Vierra Reinforcement Project

Data Request Set No. 3 – Initial PG&E Responses

December 18, 2018

Structure Diagram of Pole 1

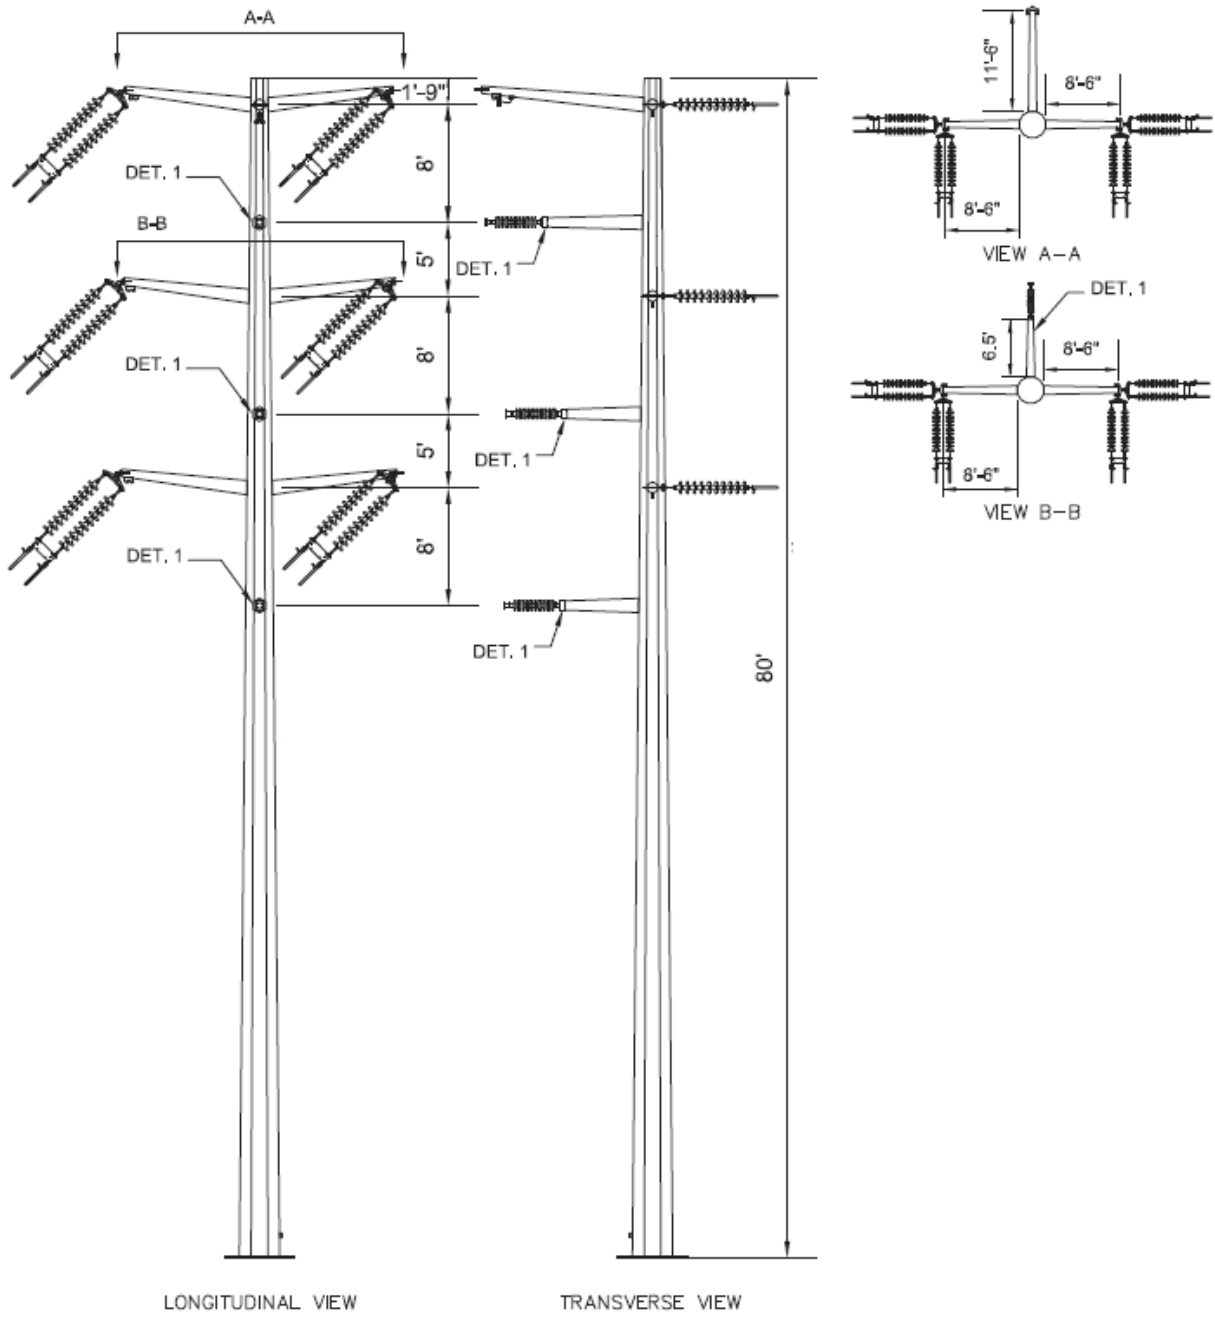
2. Please provide a detailed description of how the new line at pole #1 connects with the existing Tesla-Stockton Cogen line, and provide a structure diagram consistent with the description. Is an additional pole needed (addition to pole #1) to facilitate the connection of the new and existing lines?
3. Please provide an aerial diagram that shows any additional project components that would need to be installed to facilitate the connection of the new line at pole #1 with the existing Tesla-Stockton Cogen line. Please show the location of the additional components with respect to the existing setting.

1. There is no need for a new line parallel to the railroad spur. The new double circuit line will cross the railroad at 90° and connect to pole #1 on the west side of the railroad spur.
2. Pole #1 will be located between existing poles on the Tesla-Stockton CoGen line. It will create a break in the existing Tesla-Stockton CoGen line in order to connect the new double-circuit power line, comprised of the Tesla-Vierra and Vierra-Stockton Cogen Junction 115 kV power lines. In addition, pole #1 will support the Kasson-Louise 60kV line and a shield wire. Please see the attached diagram.
3. Please see attached diagram.
